**RE: SUBMISSION TO AN BORD PLEANÁLA IN RESPECT OF THE PROPOSED DART+ COASTAL NORTH RAILWAY ORDER 2024 – NORTHERN LINE BETWEEN DUBLIN CITY CENTRE & DROGHEDA INCLUDING THE HOWTH BRANCH IN RELATION TO PROPERTY AT CHANTICLEER, MCGRATH'S LANE, DROGHEDA, COUNTY LOUTH**

**ABP REF: 320164-24 – RAILWAY ORDER**

**LAND PARCELS FOR PERMANENT LAND ACQUISITION AS PER BOOK OF REFERENCE: DCN.5038.P.14(A); 5038.T.14(A)**

Figure 3: Extract of Property Plan No. 38 showing approximate location of our client's lands to be Permanently Acquired (Irish Rail)

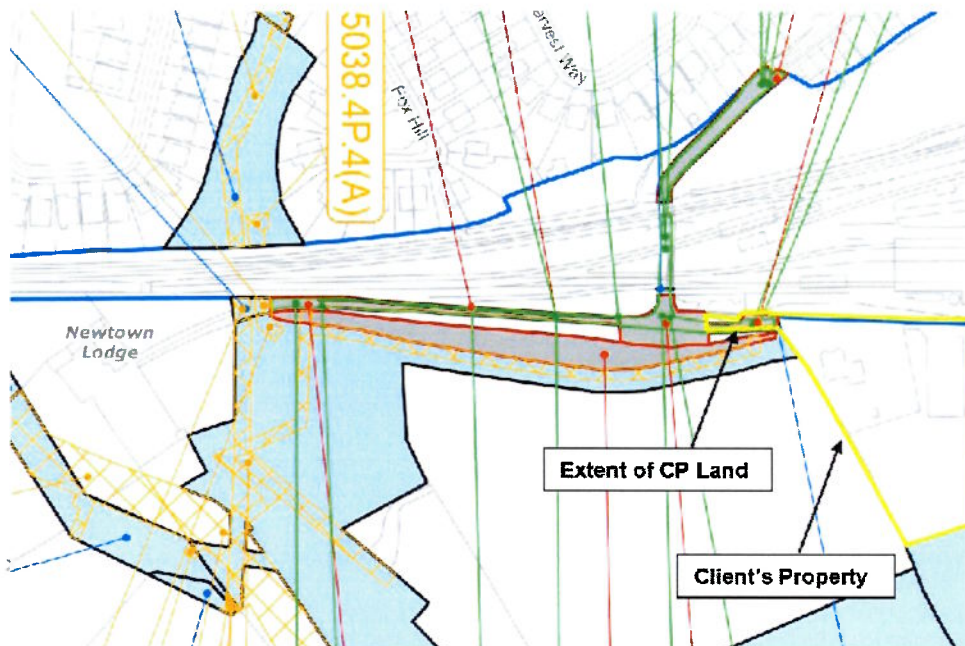
2.3 We also note the 'Right of Way to be Extinguished or Interrupted' in Figure 3 outlined in green which will have a direct impact on our client's ability to access McGrath's Lane and bridge which is proposed for demolition. The orange hatched areas denote the 'Rights of Way to be Acquired', indicating the new access on greenfield lands north of the existing McGrath's Lane and the proposed significant area of land raising and embankment required associated with proposed new railway bridge. This route links to the recently constructed link road serving Newtown View residential development and connecting this to the R150 Marsh Road.

Figure 4: Location & Extent of Construction Compounds (Irish Rail)

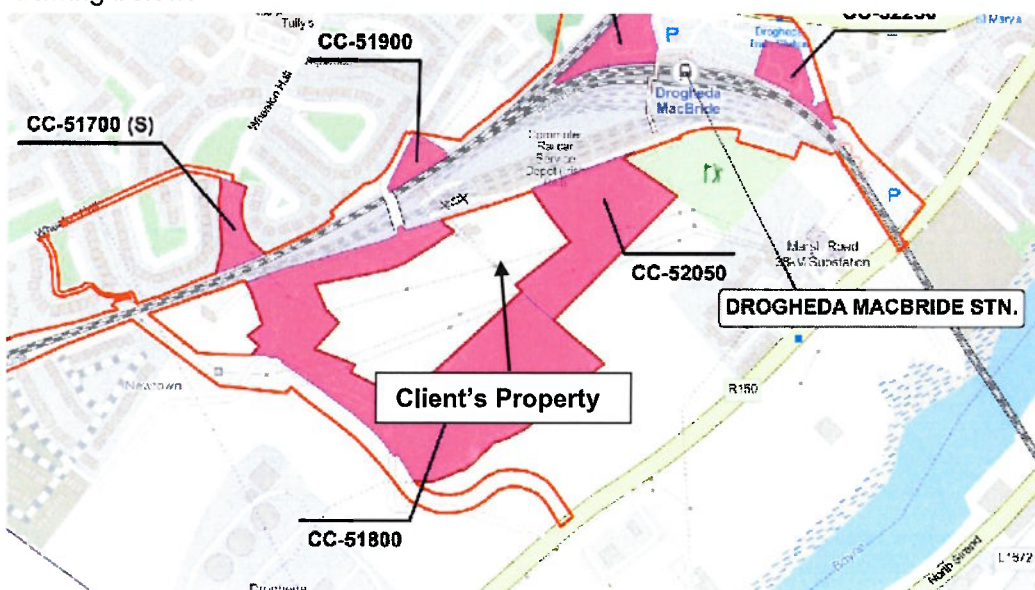
2.4 In addition to the proposed area to permanently acquired by compulsory purchase which includes vehicular access, established grassed verges and trees, the immediate area to the east and north of our client's lands have been identified for use as 'Temporary Construction Compound Areas' shown shaded pink in the drawing below.

- 2.6 Mr. Rock will be subject to all of these additional works and interventions which are required outside Irish Rail owned lands to facilitate the development. This is not acceptable to our client, and it is respectfully submitted that the impacts upon our client’s property and residential amenity, as well as accessibility, can be mitigated to some extent through the consideration of reasonable alternative solutions which can be accommodated through the management of the construction phase of development.

Figure 7: Location of Rock's property in context of proposed substation (Irish Rail)

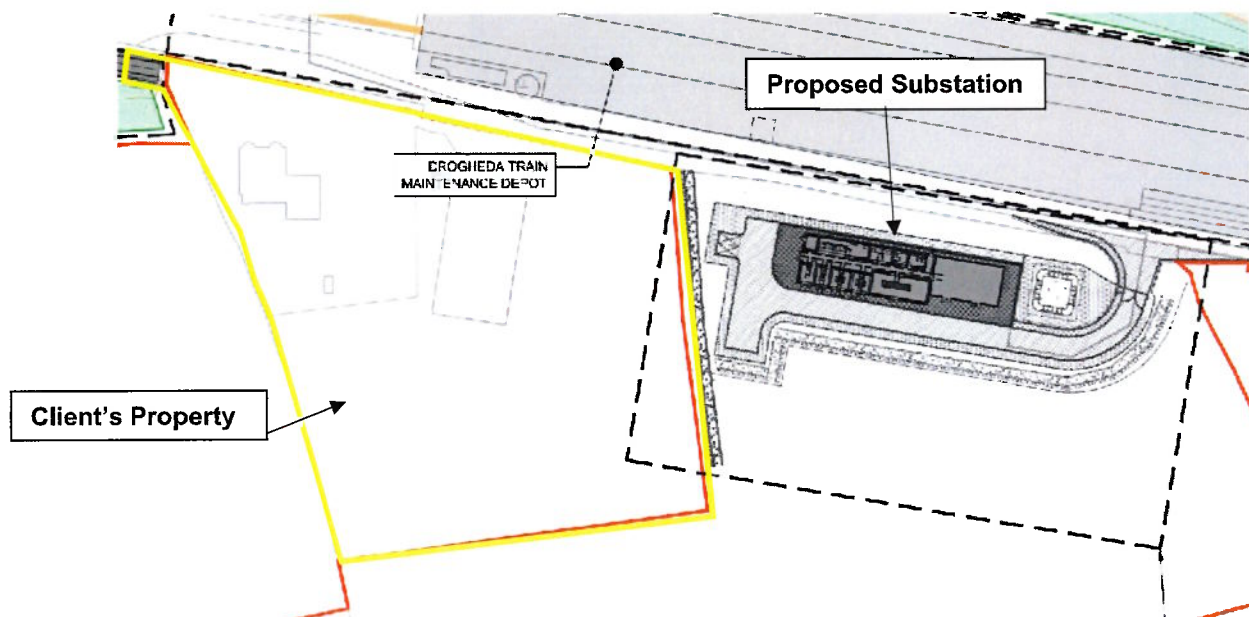
- 4.2 Our client has concerns over the lack of detail in respect of the 'Work Package Area' and the form of this encroachment as this area is not identified for any form of compulsory acquisition and appears to fall outside the red line development boundary of the application. Clarity should be sought from the applicant and details of this 'Work Package Area' provided to the satisfaction of Mr. Rock in respect of this matter.

- 4.4 **This statement is incorrect. The site location is immediately to the west of our client's ownership boundary and therefore this description should be updated to reflect the presence of a residential perimeter adjoining the substation site to the east.**

Figure 15: Extract of FIGURE 21.1: ARCHITECTURAL HERITAGE FEATURES (Irish Rail)

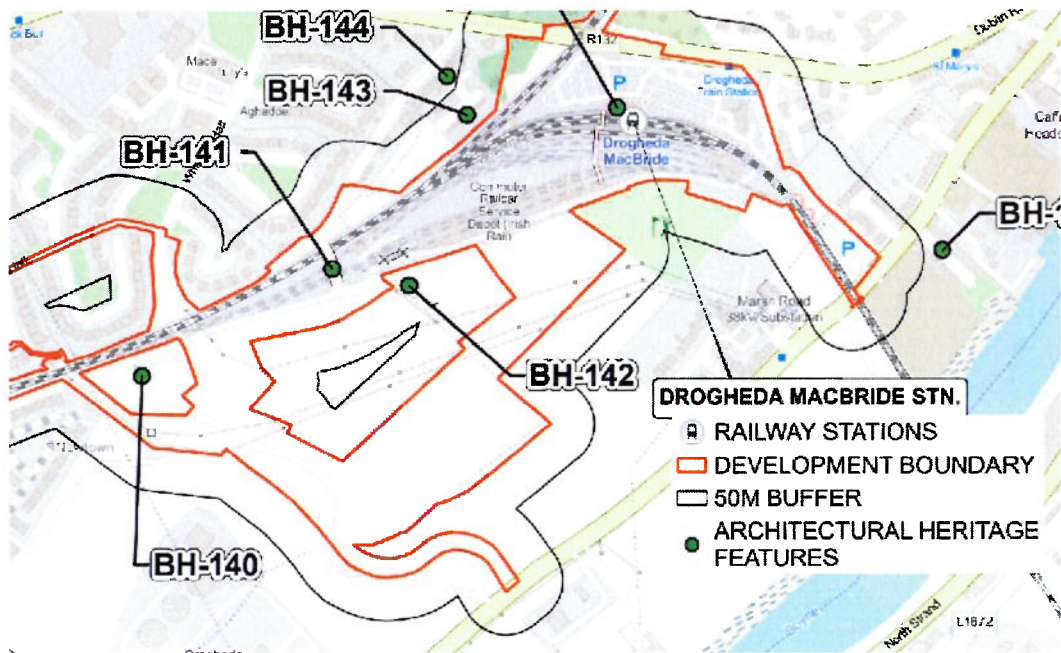
7.3 The location of the bridge Ref: BH-141 is shown in the image above, alongside our client's property Ref: BH-142.

7.4 While our client recognises the requirement for the replacement of the bridge to facilitate additional overhead heights and clearance for trains, it is considered that the design and finish of the proposed bridge be considered in the context of the heritage feature that it is replacing. **It is recommended that the proposed bridge incorporates the material from the existing Railway Terrace bridge into its construction to retain an element of architectural value at the location and to benefit the character and setting of the location.**

**Figure 2.1: McGrath’s Lane Plan and Profile Drawing– Existing and Proposed (Source: DART+ Costal North Railway Order)**

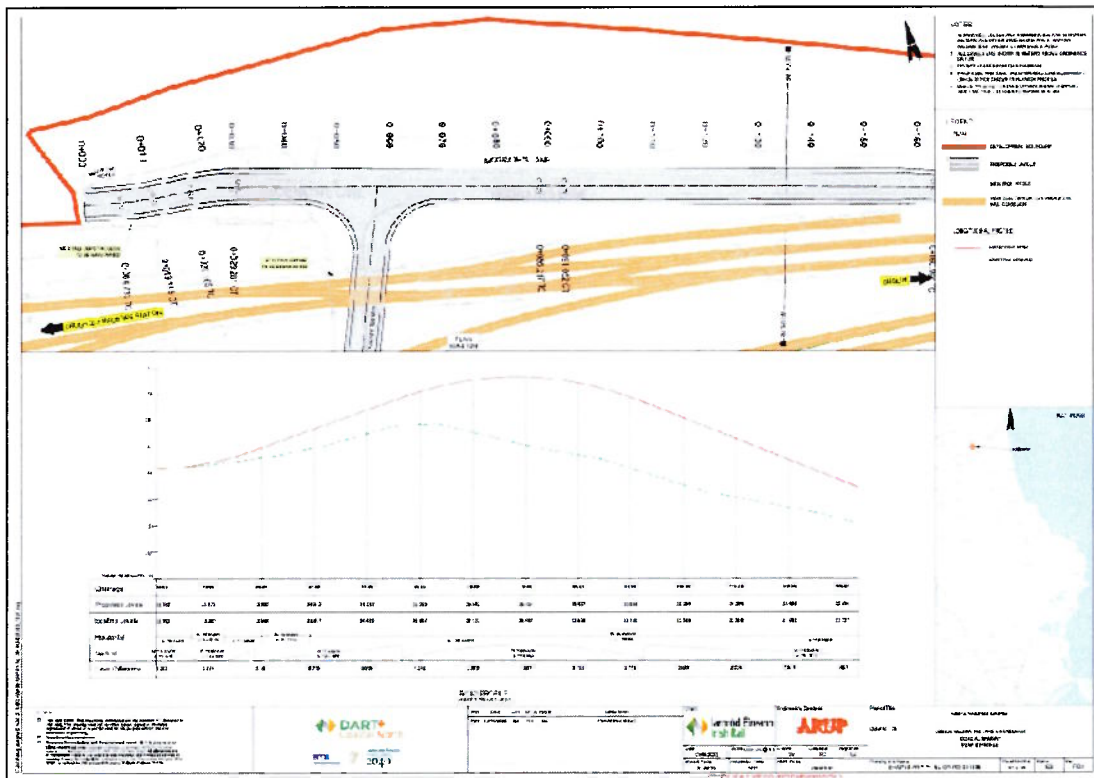
2.2.2 Figure 1.6 shows that there is a considerable difference in height between the existing and proposed road levels on McGraths Lane to the east of the overbridge (approximately 3m). This will result in a significant gradient change along the access to our client’s property. There is also a 7.2% gradient proposed to the west of the overbridge.

**Figure 2.3: McGrath's Lane Overbridge Plan and Profile Drawing– Existing and Proposed (Source: DART+ Costal North Railway Order)**

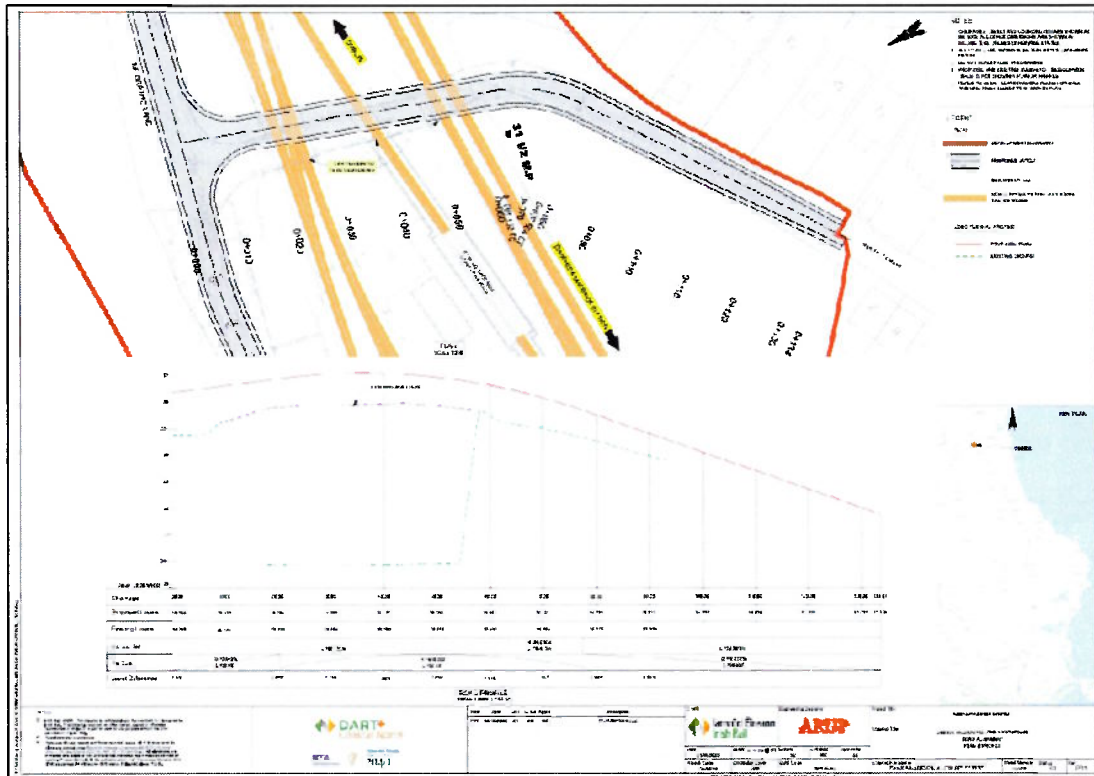
2.2.3 Figure 2.3 shows that the proposed road level is approximately 1.1m above the existing level at the centre of the overbridge. The road level is approximately 1.3m above the existing road level where the overbridge meets the proposed realigned McGrath's Lane.

**Figure 2.4: Proposed Overbridge – Cross Section**

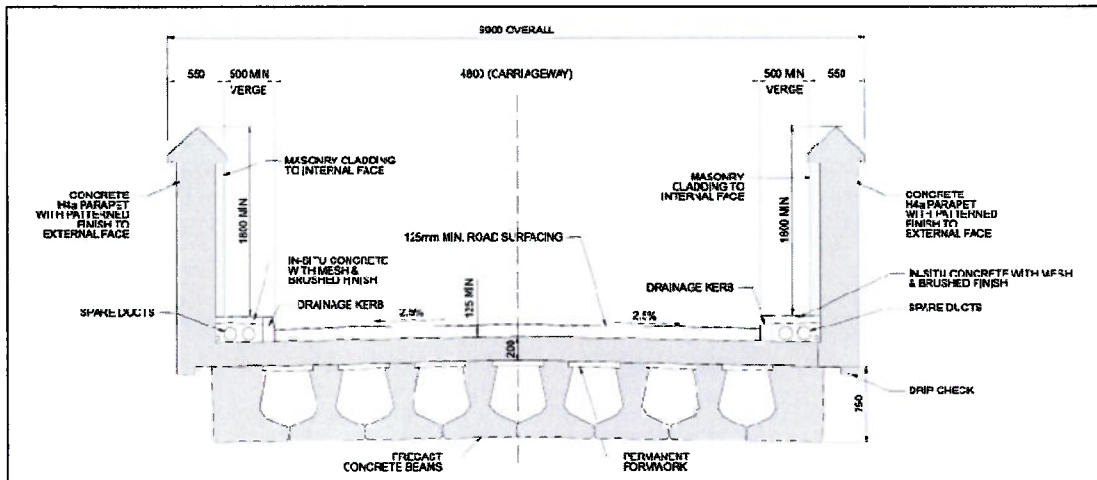
2.3.1 Figure 2.4 shows a cross section of the proposed overbridge, including a proposed parapet level of 1.8m. This is considerably higher than the existing parapet level, which will reduce views from the bridge and also give a more confined feel to pedestrian and cyclists using the new bridge, thereby reducing the amenity value of same.

**Figure 2.5: Walking Routes from Mr. Rock's Property to Drogheda MacBride Railway Station**

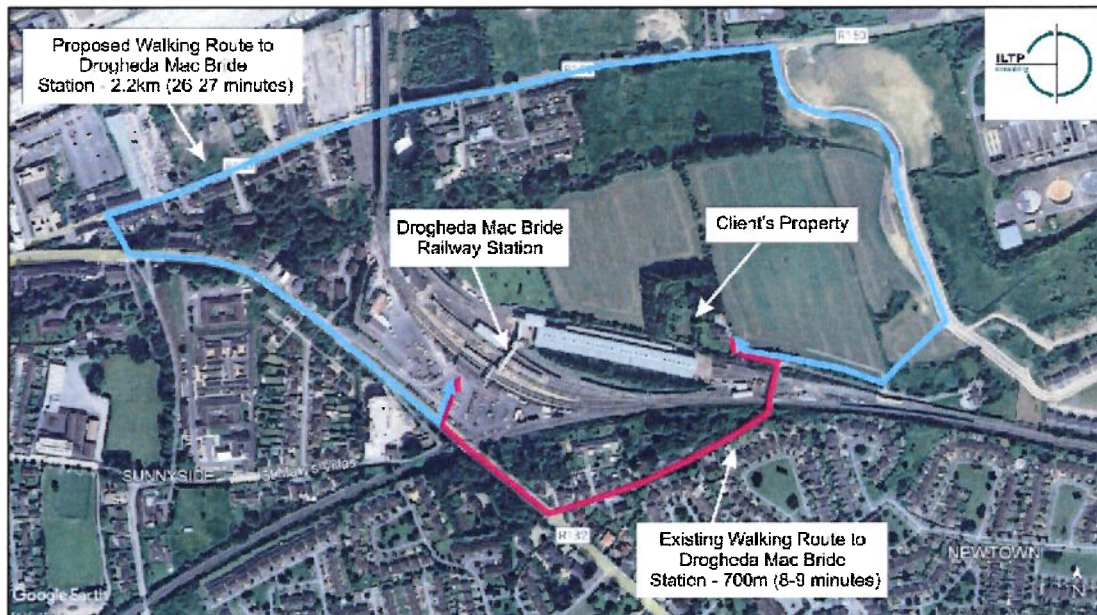
2.4.1 Figure 1.9 shows the existing walking route used by our client to access Drogheda MacBride Railway Station. It is noted that our client regularly uses this route to access Dublin via train for work. The proposed temporary route is also shown in Figure 2.5. This temporary route is approximately 3 times as long as the existing route.

2.4.2 The alternative walking route to the station during the construction phase is well outside a reasonable walk distance of our client's property. Mr. Rock regularly walks to and from the existing

**Figure 2.7: Vehicle and Pedestrian Access Route from Rail Station to Rail Maintenance Shed and McGrath's Lane**

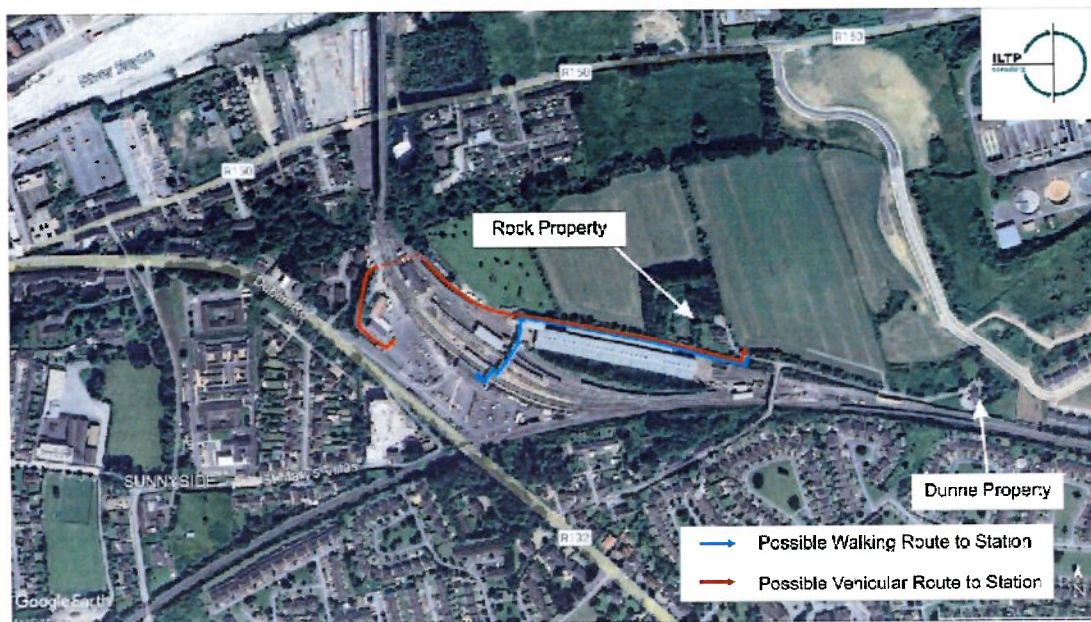
2.5.1 There is an existing access route from the existing station car park to the rail maintenance shed adjacent to our client's property, which also has a gated link on to McGraths Lane east as outlined earlier. These routes are indicated in Figure 2.7.

2.5.2 Service vehicles and pedestrian currently access the Irish Rail maintenance shed from the rail station. This area can also be accessed from McGrath's Lane as outlined earlier.

**Figure 2.8: Extract from EIAR – Construction and Public Temporary Access**

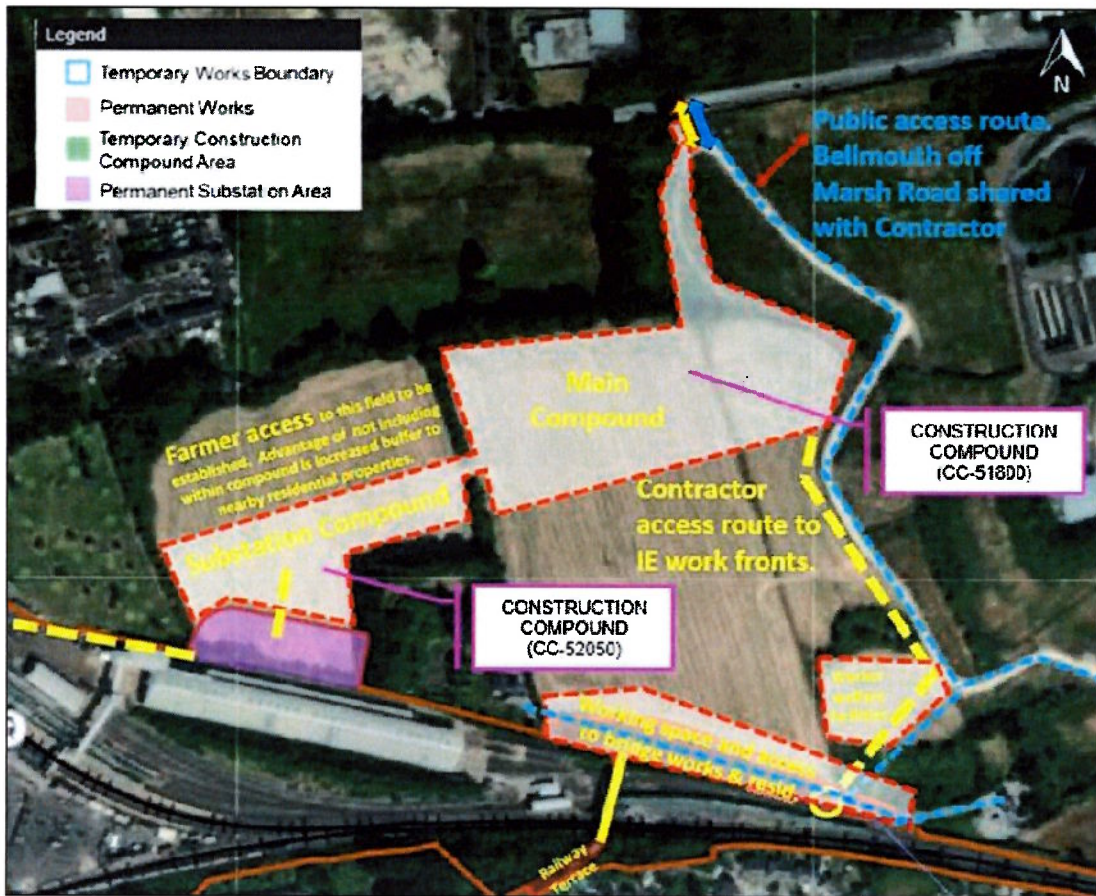
2.6.1 A temporary access route is proposed to provide access to our client's property during the construction phase, which is intended to be shared by construction access also. The location of the route is illustrated in Figure 2.8.

**Figure 2.9: Proposed Retention of Temporary Access Post Construction**

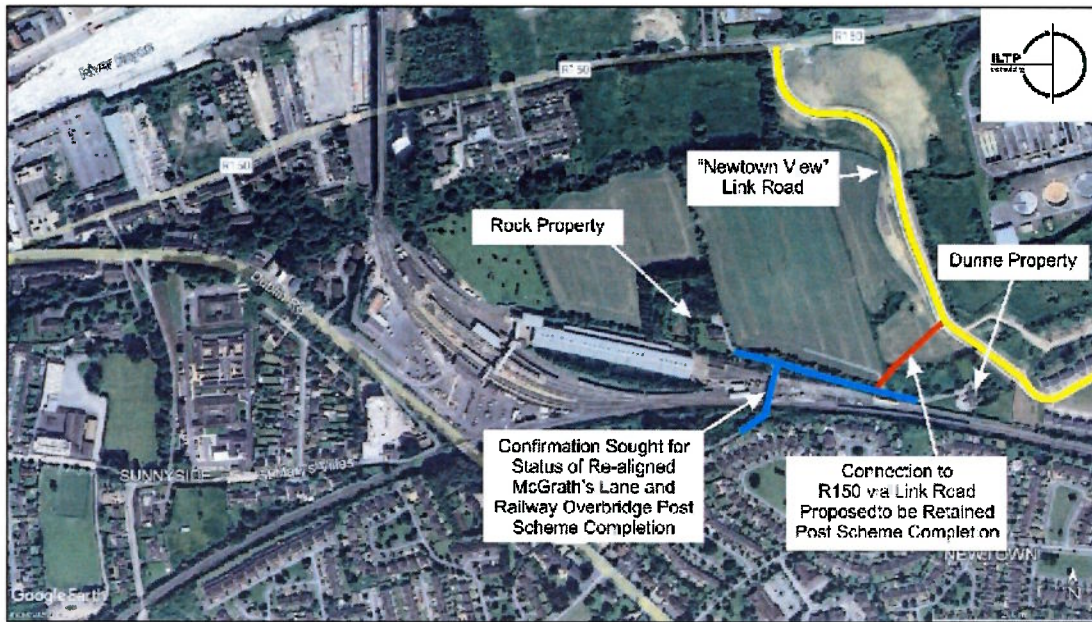
- 2.6.2 The proposals involve the relocation of McGrath Lane and the construction of a temporary access to our client lands for the construction stage. The proposed temporary access is summarised in Figure 2.9.
- 2.6.3 We note there are no detail provided as to the design of this temporary access route in term of cross section and alignment and our client would request detail of same to be provided.
- 2.6.4 Rather than simply remove the temporary access route ILTP are proposing that same be retained post the completion of the DART+ scheme as this would give an alternative access route to our client and neighbouring zoned lands. It would also provide improved cycle and walking access from the new residential development to the rail station.
